Addendum 42: Regulation No. 43

Revision 2 – Amendment 5

Supplement 12 to the original version of the Regulation: Date of entry into force: 24 October 2009

UNIFORM PROVISIONS CONCERNING THE APPROVAL OF SAFETY GLAZING MATERIALS AND THEIR INSTALLATION ON VEHICLES

"Laminated glass panels other than windscreens

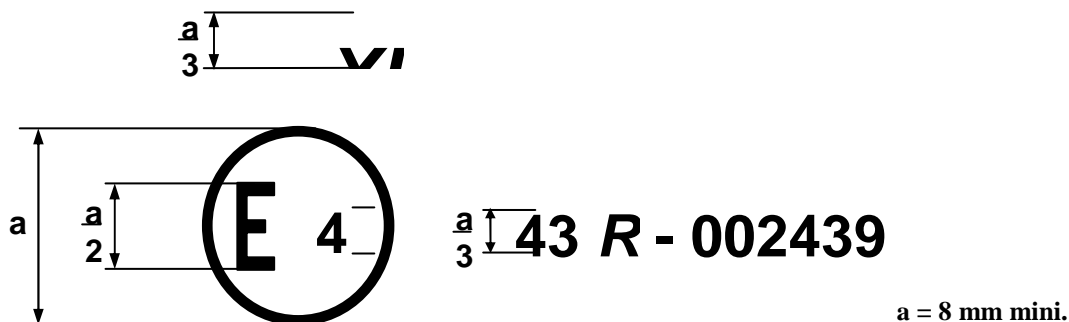
Add the following approval mark examples, to read:

The above approval mark affixed to a laminated glass pane other than a windscreen, shows that the component concerned has been approved in the Netherlands (E 4) pursuant to Regulation No. 43 under approval No. 002439. The approval number indicates that the approval was granted in accordance with the requirements of Regulation No. 43."
